**MACEDONIA PLANNING COMMISSION  
PUBLIC HEARING  
NOVEMBER 21, 2022**

**MACEDONIA PLANNING COMMISSION  
MEETING AGENDA  
NOVEMBER 21, 2022**

**TO:** Nicholas Molnar, Mayor  
and Macedonia Planning Commission

**SUBJECT:** Chipotle Drive-thru Addition (revised plans) – 8195 Golden Link Blvd.

**PROPOSED LAYOUT**  
SCALE: 1"=20'

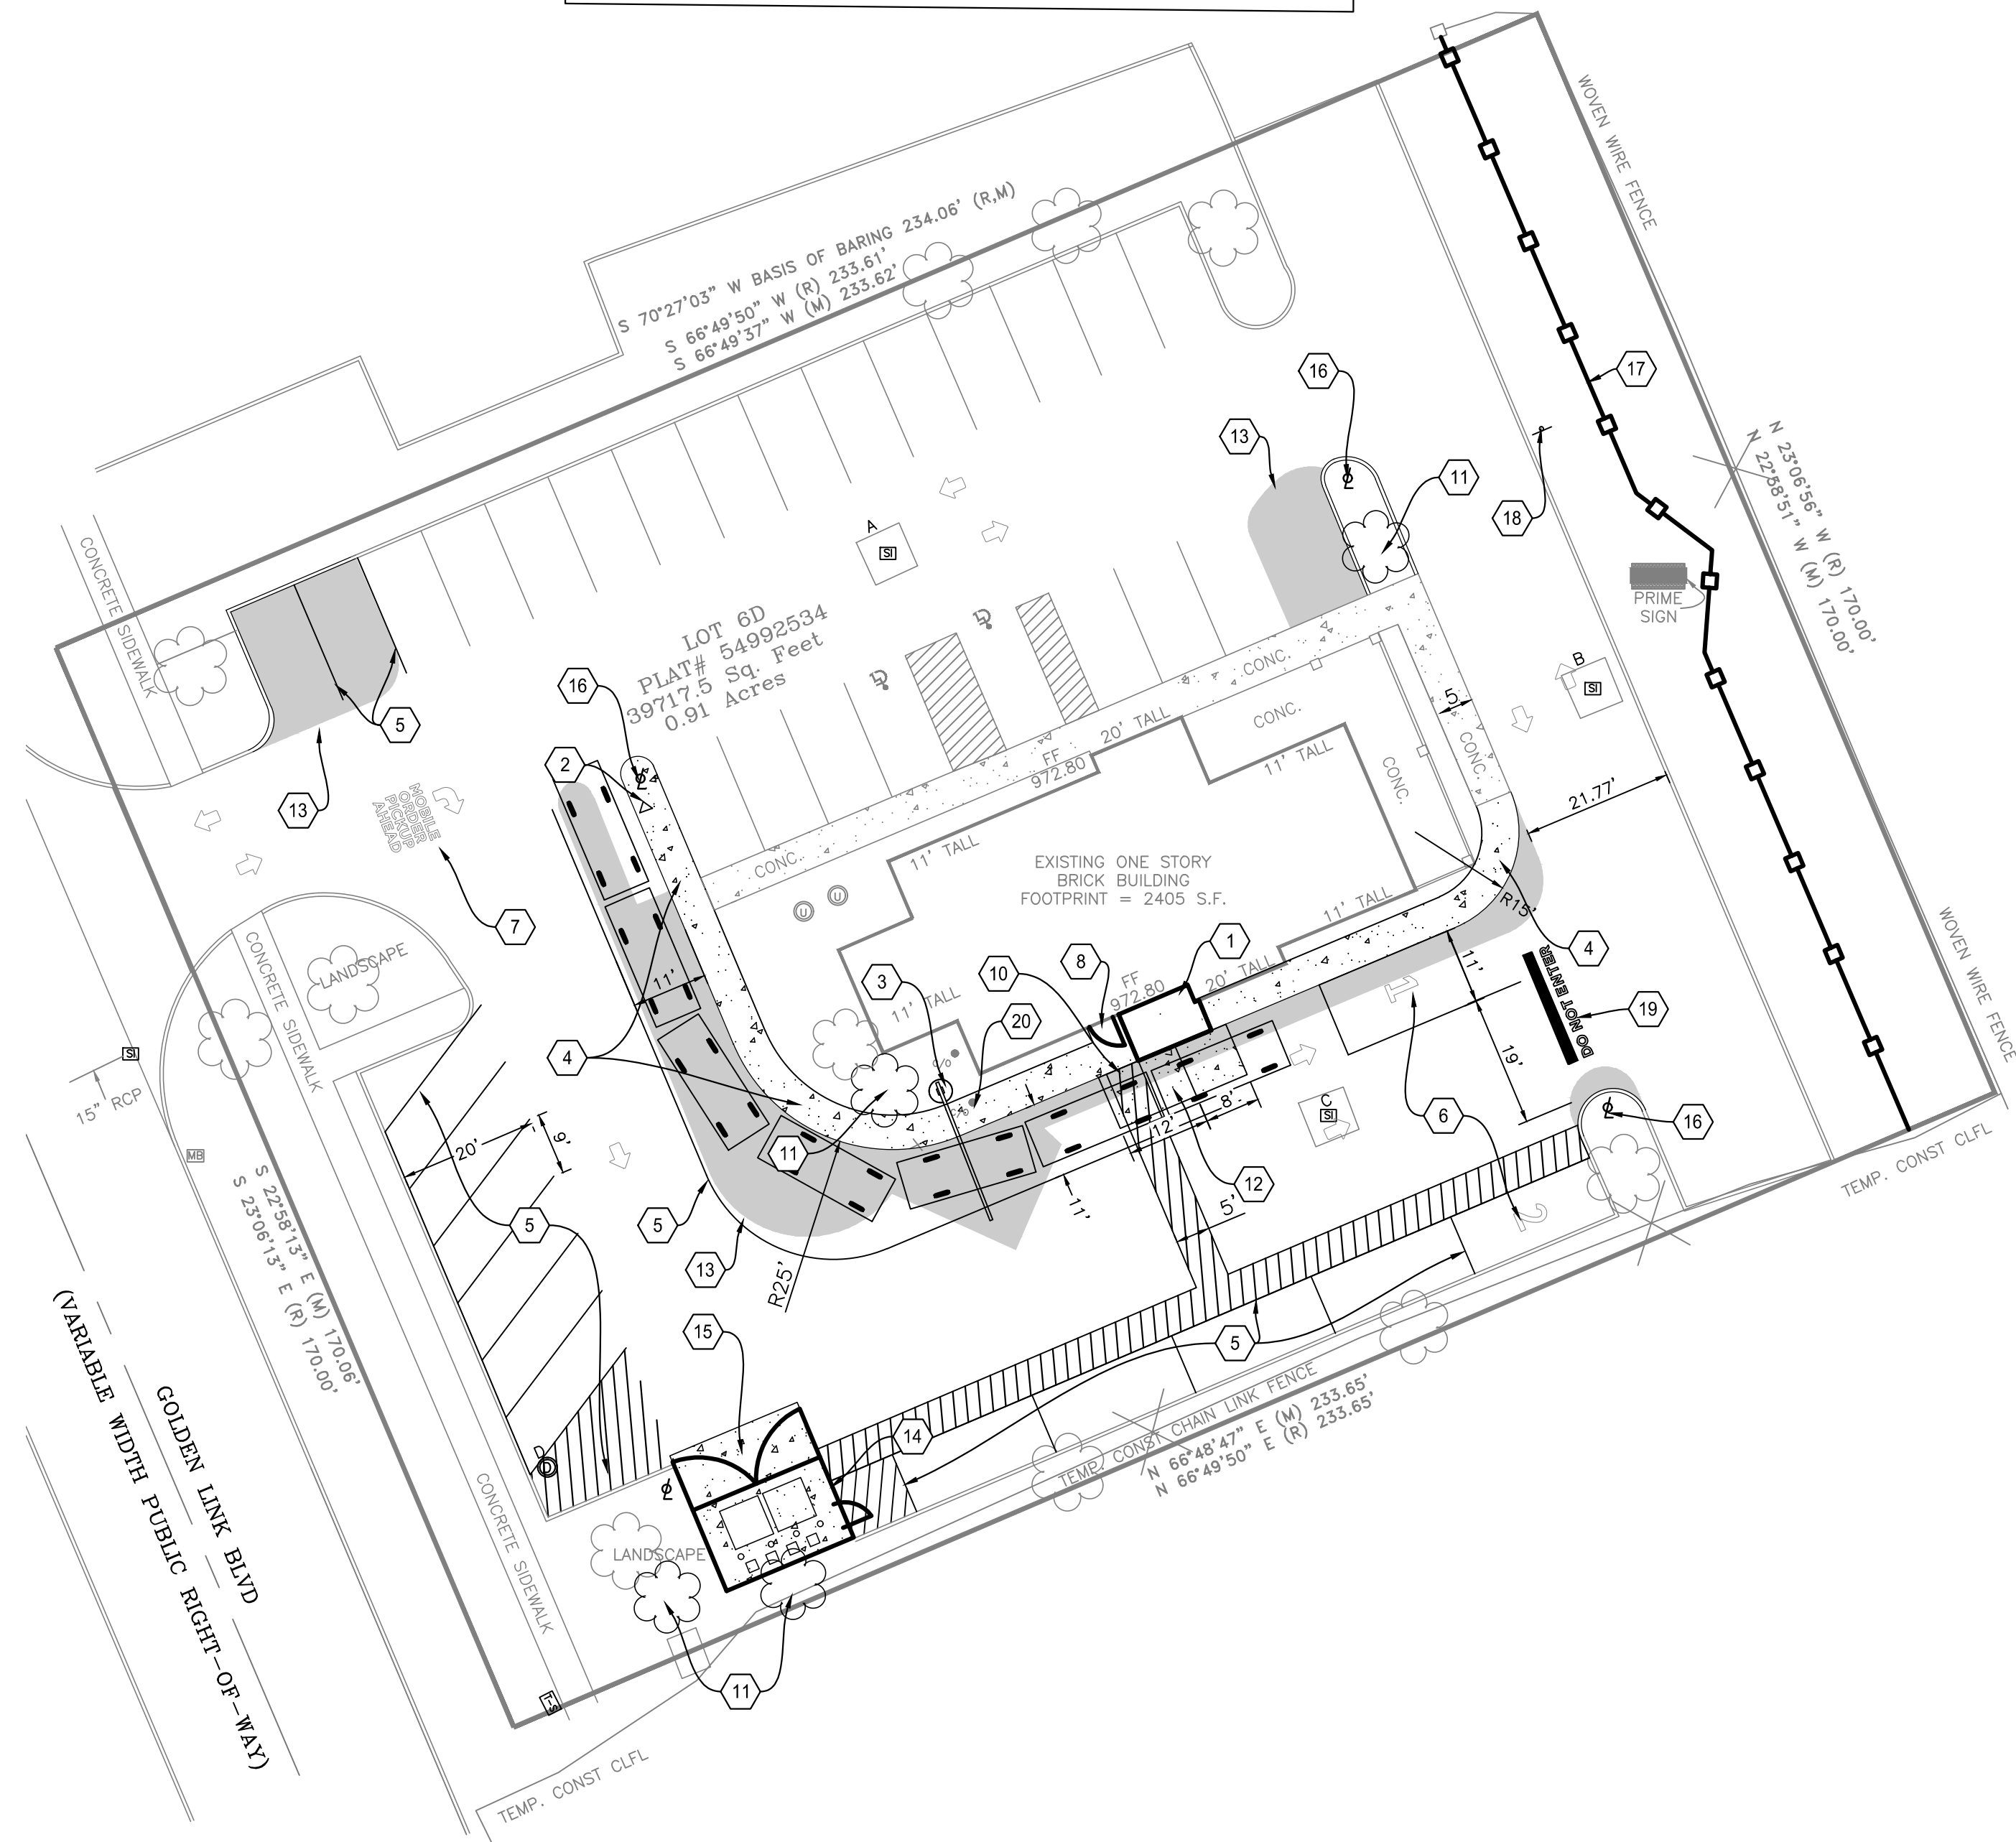
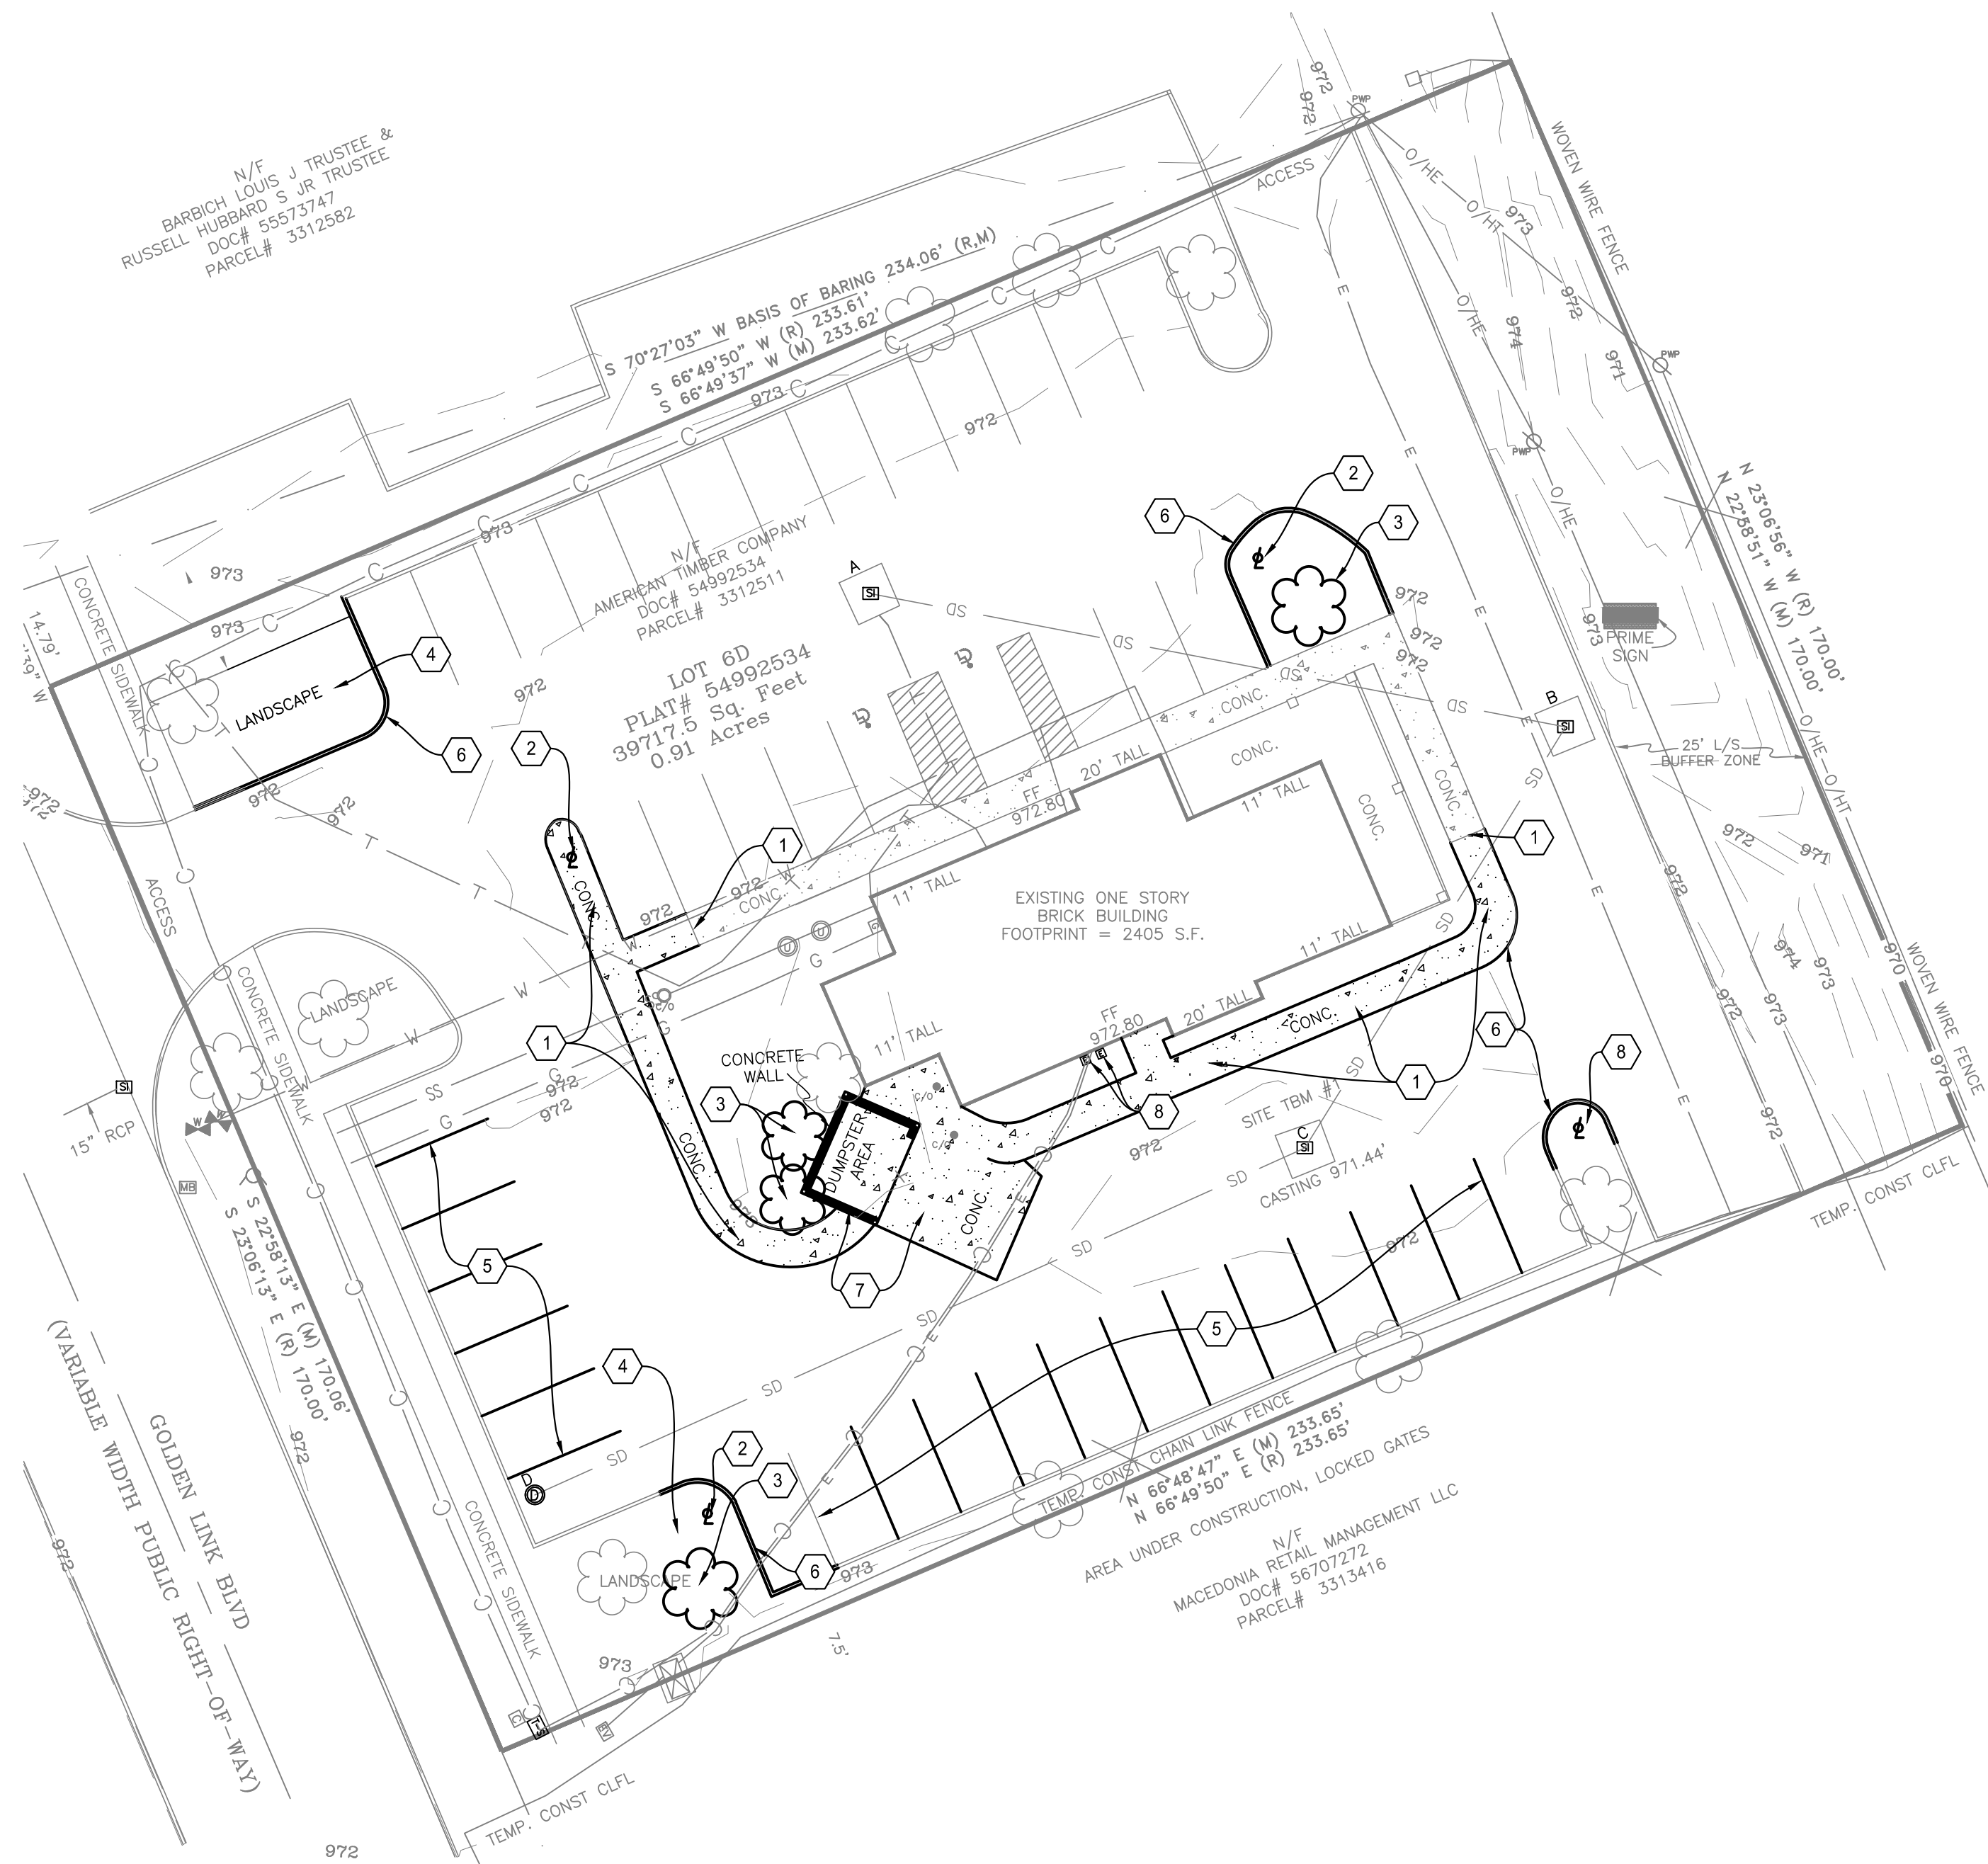
- 1) The south building elevation will receive a new drive-thru lane and associated pick-up window. The previous proposal created a 10-foot-wide one-way drive-isle with 60-degree parking along the western edge of the drive-isle. The revised plan creates a 20-foot-wide drive-isle coming into the site but transitions to a 19-foot-wide drive isle adjacent the five parallel mobile order pick-up spaces. **ACTION ITEM: Section 1171.11 (b) (6) requires a 22-foot-wide drive-isle when adjacent to parallel parking. To mitigate this and provide more parking, angled spaces could be utilized instead of parallel parking spaces. This would likely provide more parking and reduce the drive-isle minimum width to 19 feet.**

**Consideration could be given to eliminating the landscape island near the end of the east end of the parallel parking spaces to provide additional parking. This approach will also provide more separation from relocated garbage dumpster from the parking spaces.**

**provided. This will require a revised site design but will improve the overall layout and traffic flow.**

Given the need to rethink the overall site layout and the need for a parking variance, I believe this proposal should be continued to a future meeting to review a revised site plan. Future submittals need to be drawn to scale and on a full-sized 11"x17" sheet for ease of review.

**EXISTING ELEVATIONS**

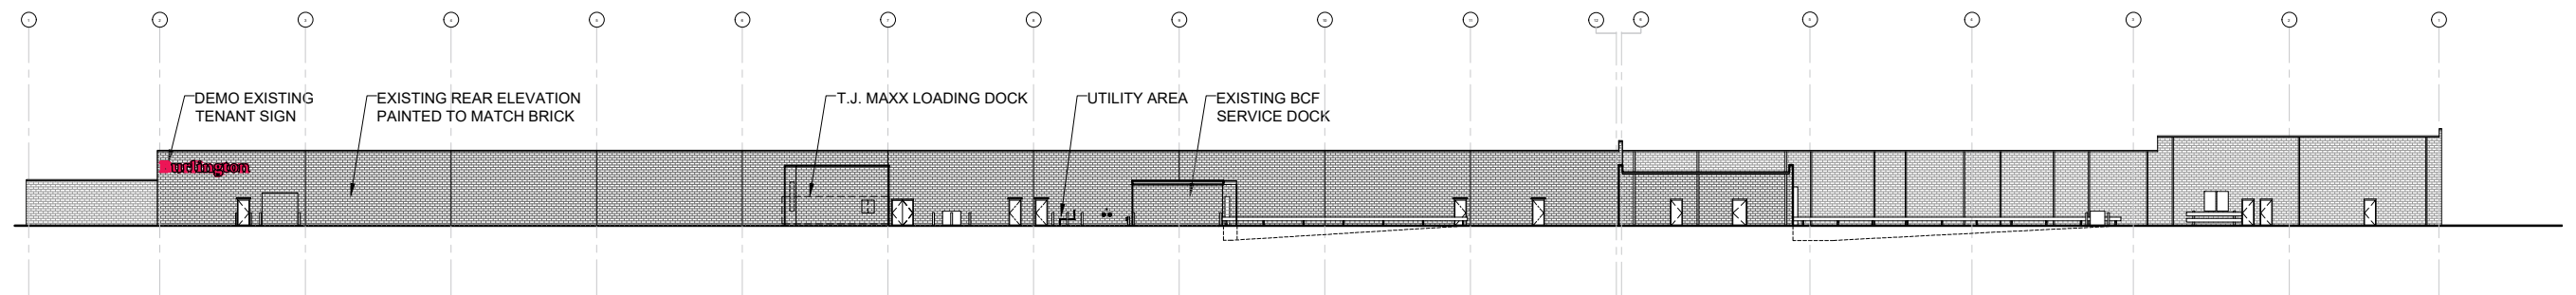
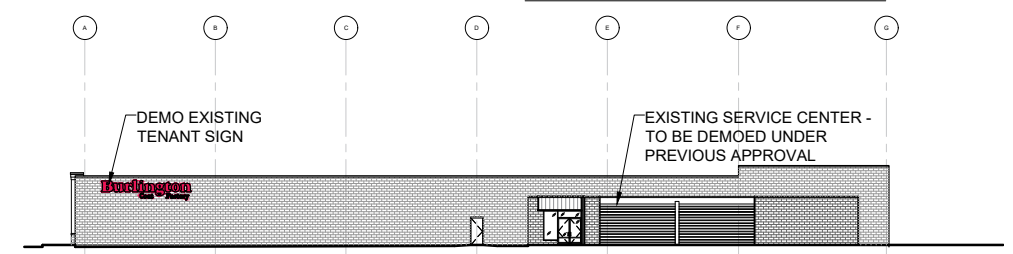
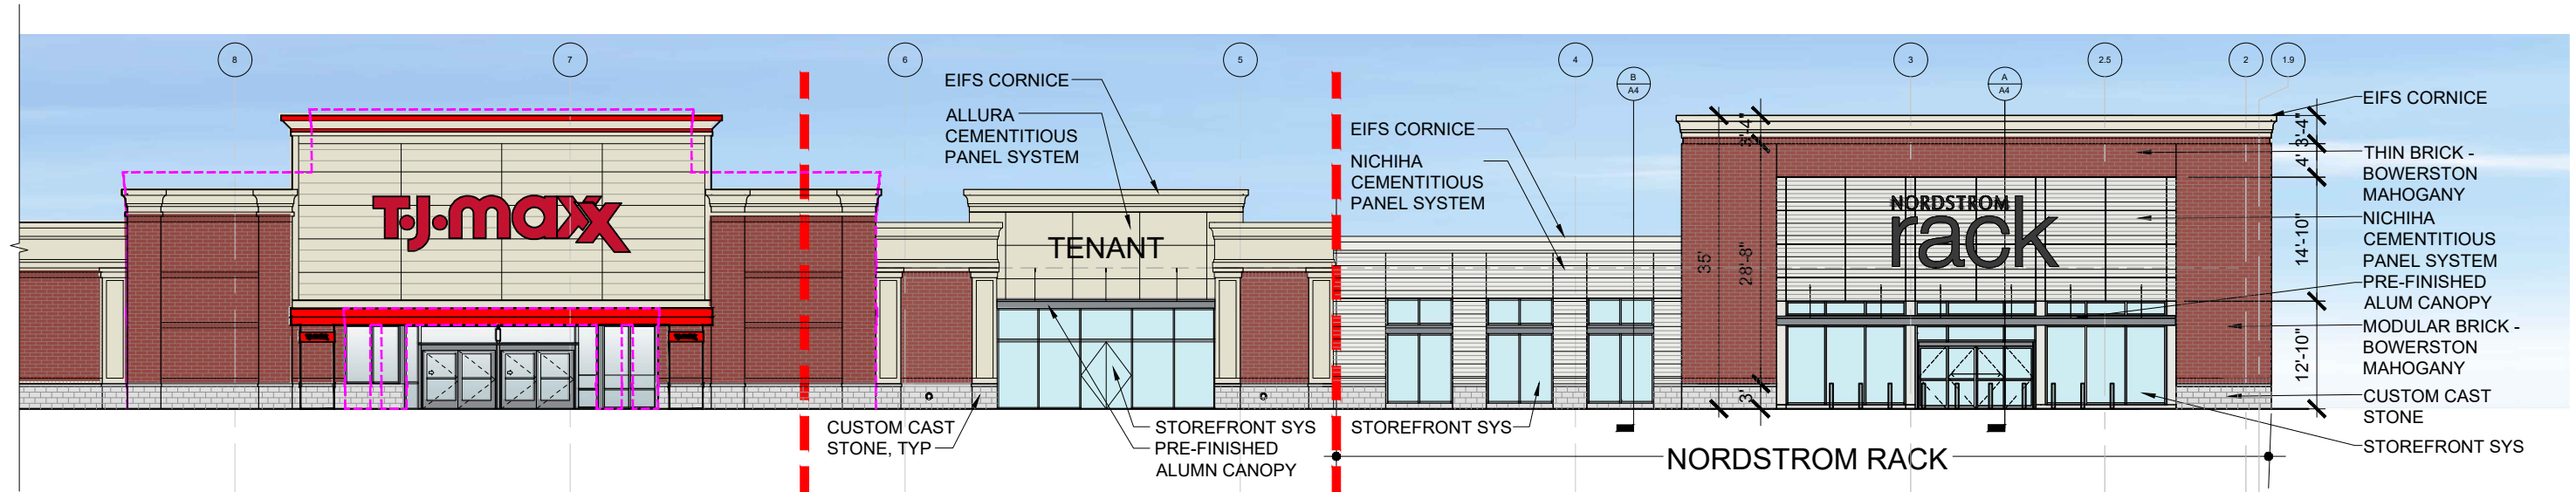
the Commission to confirm if this element will be eliminated with the Nordstrom Rack project since Sheet 3 of the architectural plans also states that removal is included under previous approvals.
